# Mid Cibolo Creek (Segment 1913) TMDL for Dissolved Oxygen Summary Outline – May 15, 2007

**Response to Public Comment**  
**TMDL for Dissolved Oxygen in Segment 1913 - Mid Cibolo Creek**  
 May 15, 2007

# One Total Maximum Daily Load for Dissolved Oxygen in Mid Cibolo Creek

Segment Number 1913

Figure 1. Project Watershed

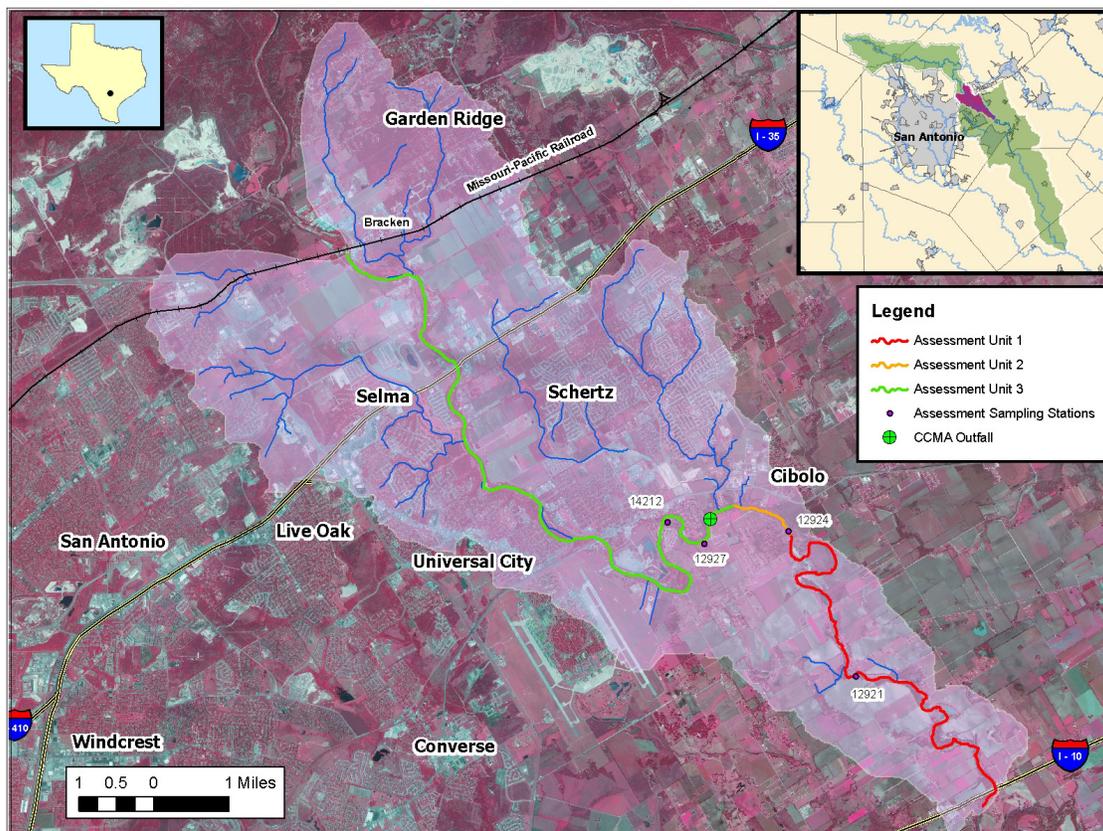
019	4/11/2007	Stakeholder email	<p>"Land use in the area is primarily pasture and forest, ... . However, land use is changing due to residential development ..."</p> <p>I think that an analysis of the present conditions removes "forest" from the second ranking. Figure 2 (Land Use) identifies the areas that were forests as "Natural" however studying recent aerial photographs show most of these zones to be almost completely populated with residential communities. I believe that the present conditions will support whatever classification is used for mixed suburban and urban usage as the second leading land use category.</p>	<p>No changes have been made to the document based on this comment.</p> <p>The most recent data available for landuse determinations was developed in the early to mid 1990s. As a result some of these classifications will not represent current conditions. The development of quantifiable data to adequately define land use classifications for the entire watershed would be time consuming and costly. The statement, “..However, land use is changing due to residential development...” attempts to address the lack of recent data.</p>

020	4/11/2007	Stakeholder email	"The upper portion of Mid Cibolo Creek is included in the Edwards Aquifer recharge zone; ..." Maps	The following change has been made to the last sentence of the 2 <sup>nd</sup> paragraph in the Problem

from the TCEQ website as well as other websites about the Edwards Aquifer have the recharge zone ending about a half mile further upstream. In fact the upper-most mile of Mid Cibolo Creek (segment 1913) seems to mark the boundary between the Edwards Aquifer transition zone and the portion of Texas having no connection to the aquifer (frequently called the coastal plains).	Definition section. The upper portion of Cibolo Creek (this represents stream segment 1908 – Upper Cibolo Creek) is included in the Edwards Aquifer recharge and contributing zones; as a result, there is typically little to no flow into the headwaters of Mid Cibolo Creek under normal conditions.
021	4/11/2007	Stakeholder email	Some illustrations of segment 1913 (such as Figure 2) have its downstream limit about a half mile upstream of IH10, while other illustrations (such as Figure 1) show the limit to be downstream of IH10. Written descriptions of the segment support the location of the limit to be downstream of IH10.	Figure 2 has been changed to match the description of the segment extending to the area below IH10.

Figure 6. Predicted Downstream Dissolved Oxygen Concentrations Based upon QUAL-TX Calculations

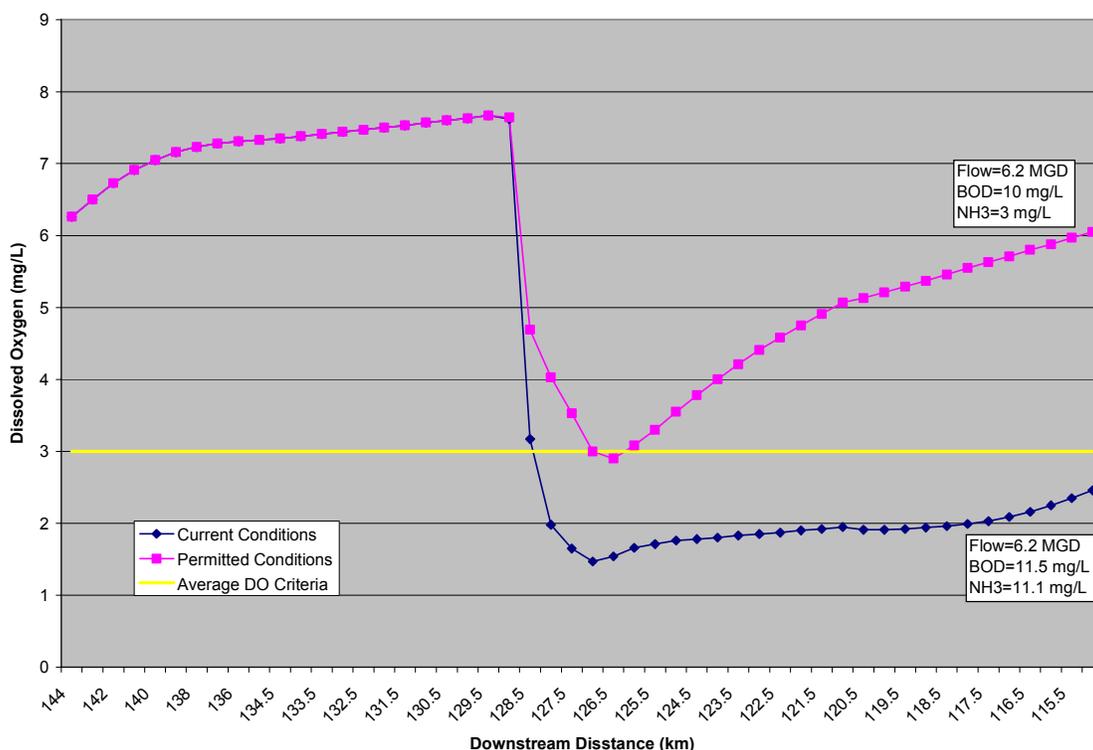
hour dissolved oxygen concentrations.”
018	4/30/2007	Consultant for CCMA	<p>On page 15 an explanation is given as to why the model predicts DO violations, even though none occurred. The conjecture is that QUAL-TX is a steady state model that does not account for DO dynamics that result from eutrophication caused by excess nutrients. It has not been demonstrated that there are excessive nutrients, and it is inappropriate to state that eutrophication is the cause of the oxygen dynamics when this has not been proven. The difference in the modeled and measured DO values may be due to:</p> <ul style="list-style-type: none"> <li>a. Use of wrong flow quality values,</li> <li>b. The conservative nature of the QUAL-TX model, or</li> <li>c. Inappropriate assumptions with respect to the terms applied in the model.</li> </ul>	The second paragraph on page 15 has been changed to accommodate this comment.
